FIRE SAFETY INSPECTION REPORT

Denim Processing Plant Ltd.

ACCORD ID: 23834

Date: 13 October, 2019

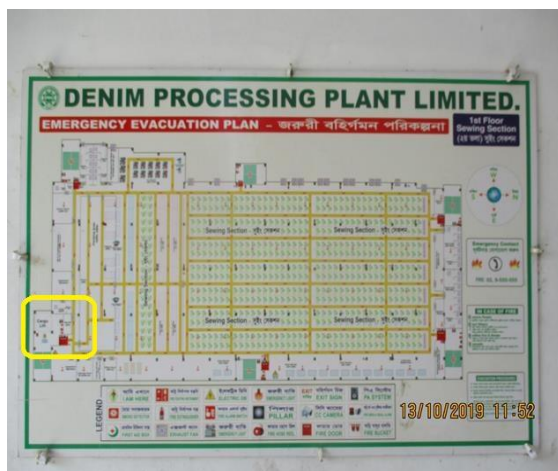
SI No.	Category	Findings	Required Action	Remediation Time Frame
F-1	Fire Rated Construction	The exit stairs are not separated from other occupancy on each floor by fire rated construction.	Provide minimum 1.5-hr fire rated doors for buildings that are 4 or more stories. Seal all unprotected openings to separate the exit stairs from work areas and other building spaces on all floor levels. Ensure that the fire doors are self-closing and positive latching and that they are provided with fire exit (panic) hardware where serving production floors. If fire doors are required to be held open for functional reasons, provide automatic closing devices tied to the fire alarm system. Once fire doors are installed, every door in a stair enclosure serving more than 5 stories shall be provided with re-entry unless it meets ACCORD standard 6.8.3.1.	Within 3 months
